# **SUBMISSIONS REPORT**

SSDA-10448 Mod 2  
Aspect Industrial Estate

Prepared for  
**MIRVAC**

Figure 1 Refinement to Concept Masterplan - Warehouse 3

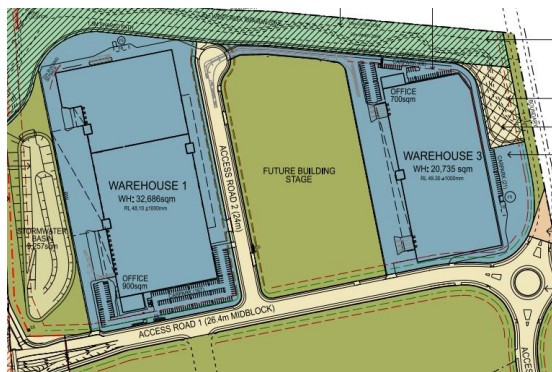
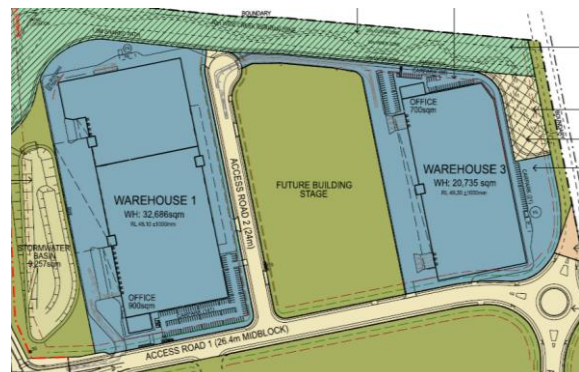
Location	Proposed Refinements
<b>Warehouse 3 Carpark Areas</b>	<ul style="list-style-type: none"> <li>Reduction of car parking spaces at the east carpark area from 27 to 21 (reduction of 6 spaces) for warehouse staff</li> <li>Increase in car parking spaces at the north carpark from 62 to 68 (increase in 6 spaces) for office staff</li> <li>Re-alignment of the east carpark space further north (closer towards the main office)</li> <li>Re-alignment of the northern carpark layout to accommodate increased number of spaces.</li> </ul>
<b>Warehouse 3 Pedestrian Access</b>	<ul style="list-style-type: none"> <li>New, dedicated pedestrian path that travels parallel to the north driveway, connecting access road 2 and the main office</li> <li>New, dedicated pedestrian path that travels along the southern, northern and eastern ends of Warehouse 3 that connects the east carpark with the main office.</li> <li>New, pedestrian crossing situated at the north carpark, between the northern pedestrian path and the main office.</li> </ul> <p><i>The refined pedestrian access arrangements are shown in Figure 2 below.</i></p>
